## TECH NOTE

RE: 100 Avenue Road Tech Note

London, UK

This Tech Note assesses the proposed landscaping measures for receptor 7 only, to confirm the mitigation near the Hampstead Theatre. The assessment is based on the plans received August 14<sup>th</sup>, 2019:

Planting location as shown in "SC-CAM-00-GF-DR-L-0111.pdf" received August 14th, 2019

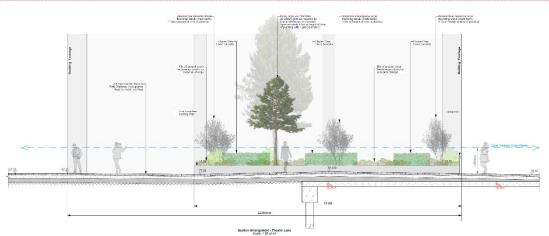
Planting has been included in Theatre Lane to the west of Hampstead Theatre, running parallel to the café facade. The proposed planting includes a planter of 0.7m height with low-level evergreen planting of 0.45m height (1.15m total height low level planting). In addition, a 4-5m tree (at the time of planting) which is of an evergreen variety is located to the west of receptor 7. Three deciduous trees of 2.5m height will also be planted within the planter, one to the south of the evergreen tree and two to the north.

We support the use of the proposed planter as mitigation given the results of the 2014 report at this thoroughfare location. The use of evergreen trees and planting is particularly beneficial.

We would conclude, based on professional opinion and experience of similar projects, that the addition of the planter in Theatre Lane would mitigate the marginal Beaufort Force 7 strong winds at receptor 7, and therefore wind conditions would be suitable for thoroughfare use. Therefore, no further mitigation is required.
